IA-32 Intel[®] Architecture Software Developer's Manual

Documentation Changes

Document Number: 252046-003

Figure 8-9. Protected Mode x87 FPU State Image in Memory, 32-Bit Format

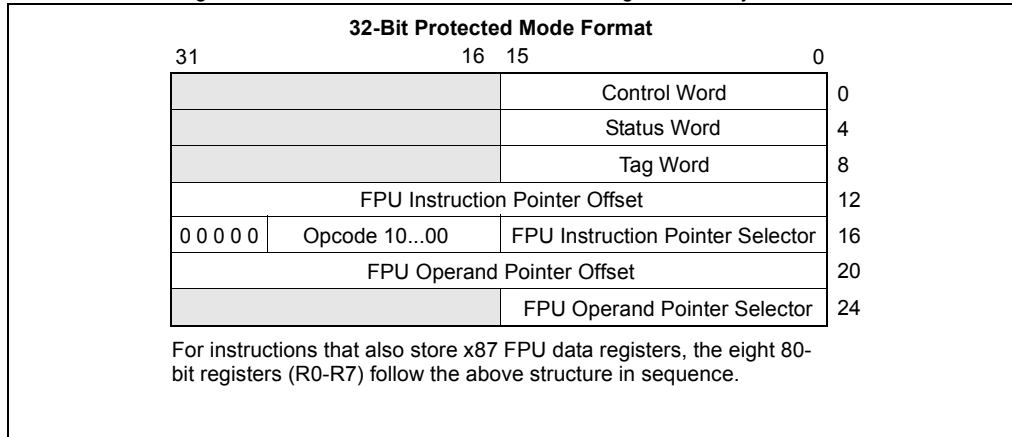
In the IA-32 Intel® Architecture Software Developer's Manual, Volume 1: Basic Architecture, Chapter 8, Figures 8-9 and 8-10 have been updated to include a short note about storage of the X87 data registers during the operation of FSAVE. Both updated figures are shown below:
